8.7. Marist Catholic College Major Project Application (Application SSD – 10473)

To highlight for Council's information planning issues arising from the Marist Brothers Catholic College State Significant Development application.

Lower level of new buildings showing auditorium and parking. Vehicle exit/ entrance is at top right of the image onto Carlow Street.

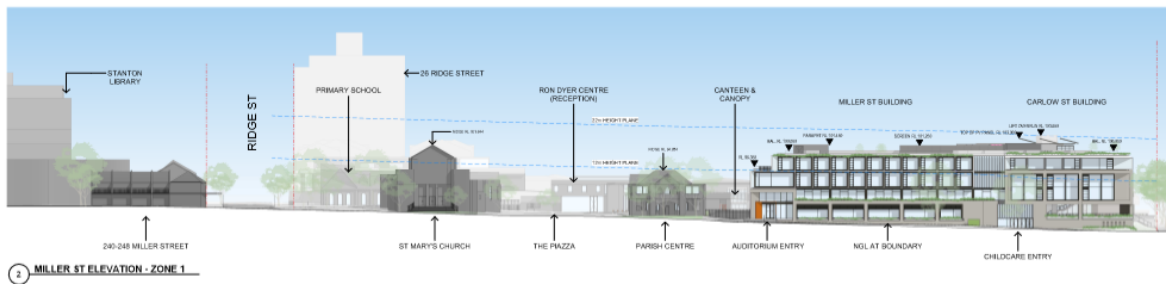
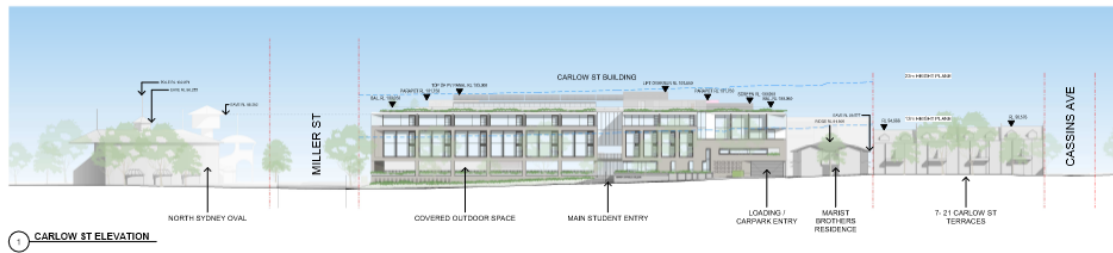
Basement carpark proposed. 2 existing driveways on Miller Street to be removed. New double driveway in Carlow Street proposed.

Significant excavation for basement parking adjacent to council property noted. Appropriate conditions will be recommended to address the above matters.

Elevations from Carlow and Miller Streets

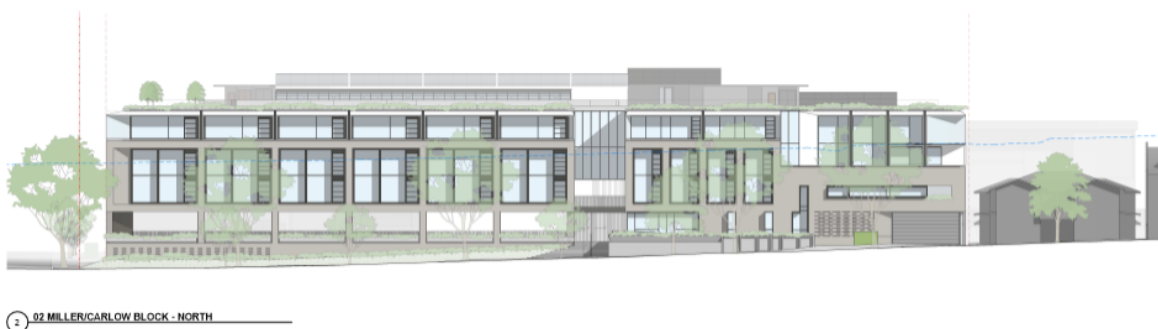
Having regard to the design principle the proposed four storey height along Miller Street and Carlow Street might not be considered to respond appropriately to the surrounding low-scale context, particularly as the height is concentrated around the perimeter of the site rather than in the centre. There is no stepping down of height towards at the edges of the site, which reinforces the monolithic form of the development.

Consideration should be given to providing a variation in building height to provide a transition between the proposal and surrounding lower scale development.

The façade provides no substantial architectural breaks or articulation, resulting in a consistent building mass along the two street frontages. The building does not relate to the low scale residential further north along Miller Street and east along Carlow Street.

The length of the development on the corner of Miller Street and Carlow Street should be broken up through physical breaks in the building façade.

The proposal is designed to focus into the site rather than out. There may be some secondary interaction/glimpses into the undercroft play area from the intersection at Miller and Carlow Streets. A setback above the first or second floor is needed to break down the 'fence like' appearance of four storeys around that corner.
